Amendments to the Drawings

Appl. No. 10/808,407 Amdt. Dated June 9, 2006 Reply to Notice of Non-Compliant Amendment of May 30, 2006 Attorney Docket: QSTR-102 Remarks

FIG. 6

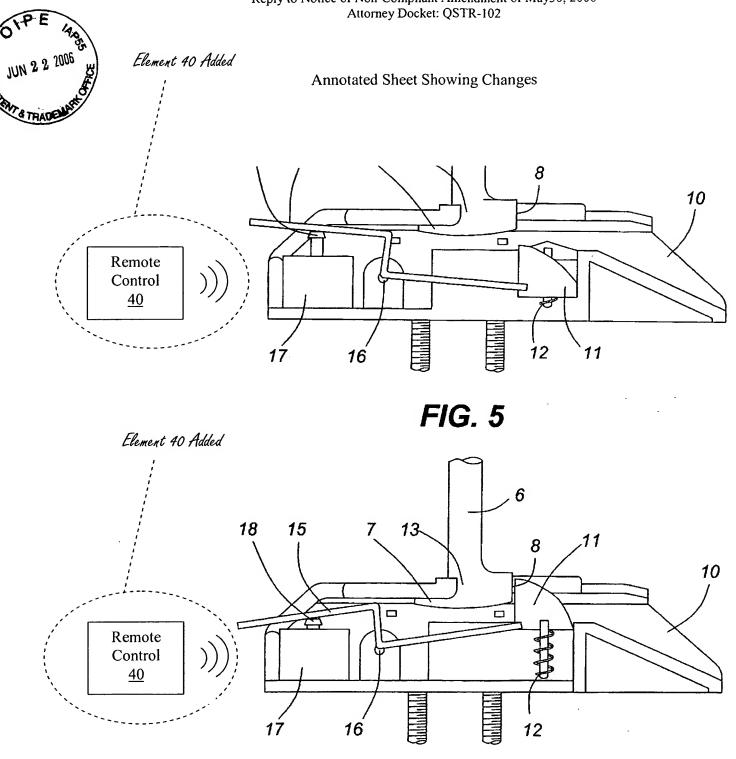
The attached sheet of drawings includes changes to Figures 5 and 6. This sheet, which

includes Figures 5 and 6, replaces the original sheet including Figures 5 and 6. In both Figures 5

and 6, a labeled rectangular box is added and identified as reference number 40 to represent the

remote control as described on page 6 lines 9-12 of the description.

First, the Examiner objects to the drawings under 37 CFR 1.83(a) for failure to show the

remote control of claims 35 and 38. 37 CFR 1.83(a) requires that drawings in nonprovisional

applications "must show every feature of the invention specified in the claims." However, the

hereby amends the drawings to illustrate the remote control in the form of a labeled

representation, in accordance with 37 CFR 1.83(a). The applicant also amends the description
